**CONTRACT NAS1-98108  
(Task Orders)**

Numerous Task Orders have been issued under Contract NAS1-98108. This file contains a sampling of Task Orders offering a good representation of work requested under this contract.

# NTF TASK/TEST REQUEST

# CHANGE NOTIFICATION SHEET

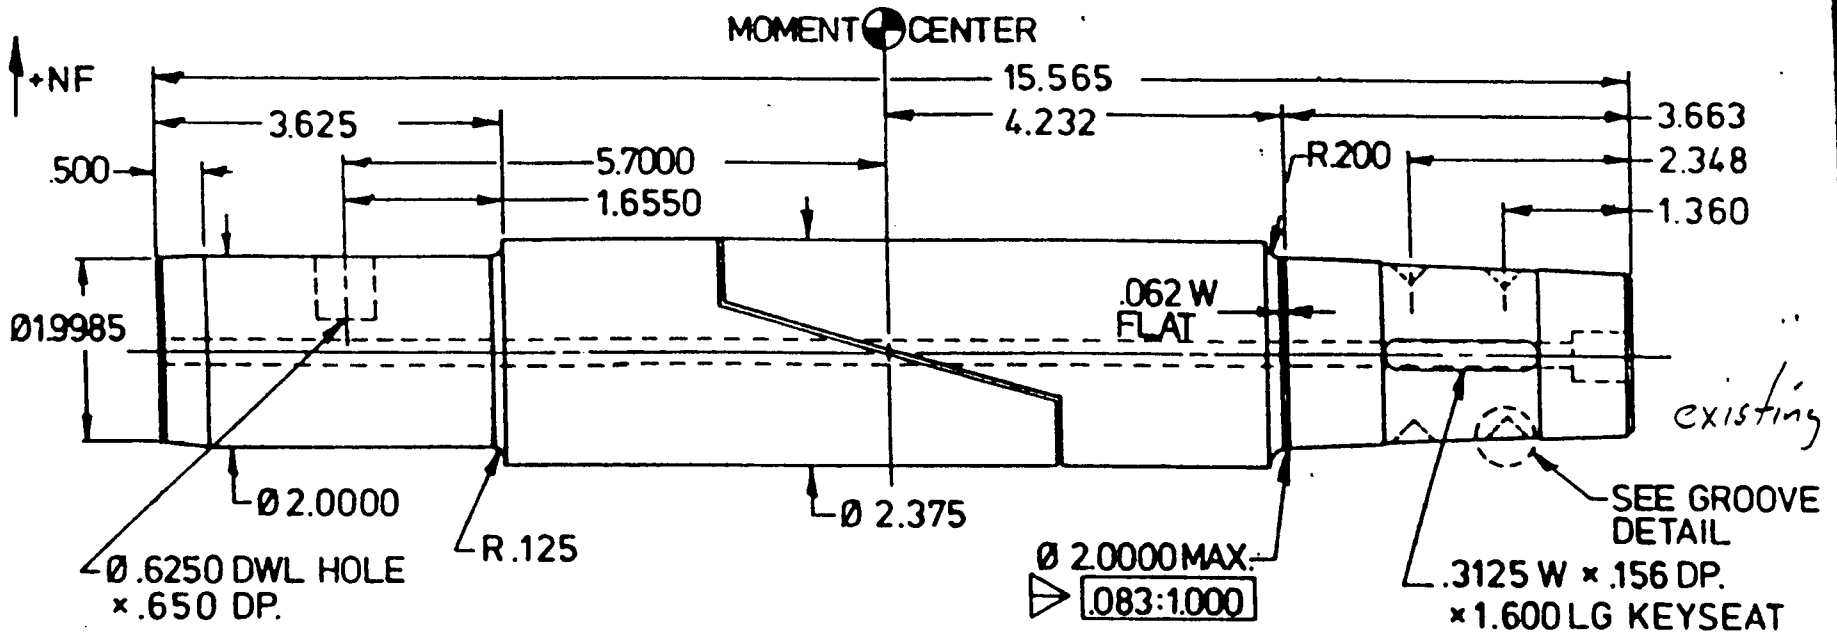
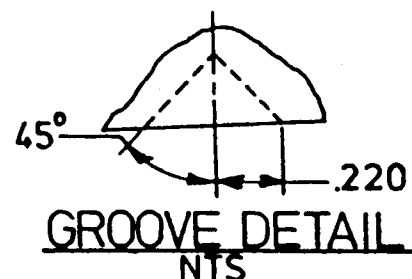
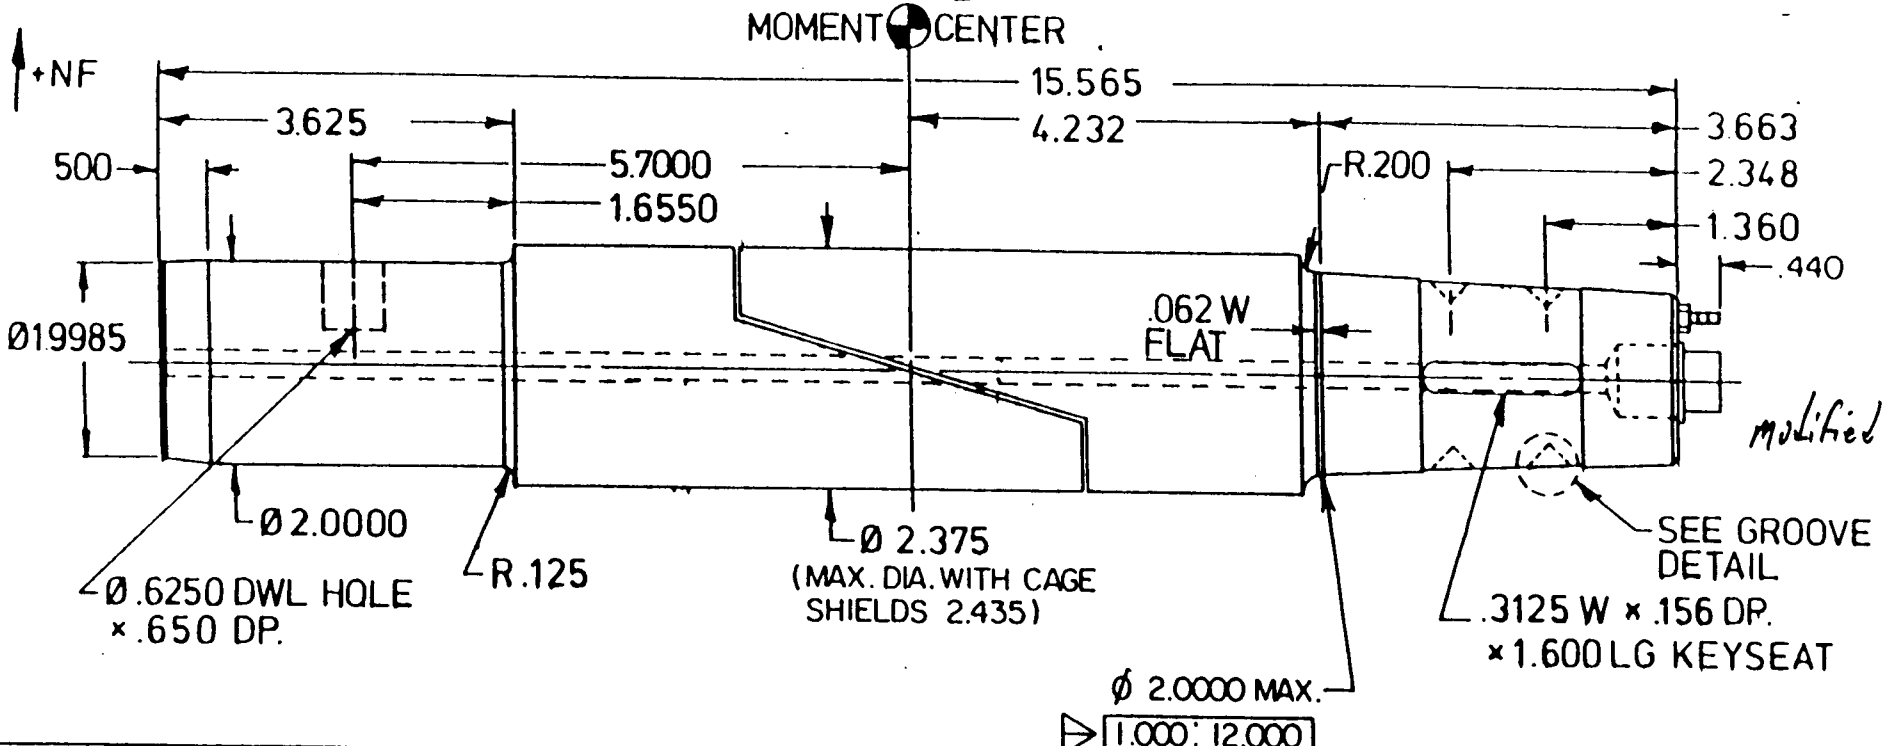
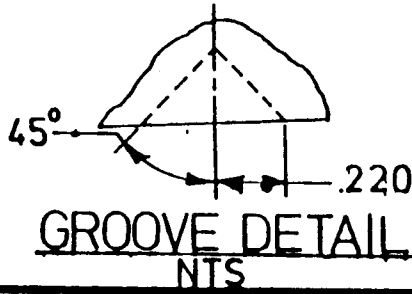
5. TASK/TEST: Modify Dummy Balances 101B+113

Modify dummy balances to simulate the wiring connector and purge tube that has been added to the live balances. This should improve the quality of hardware acceptance tests.
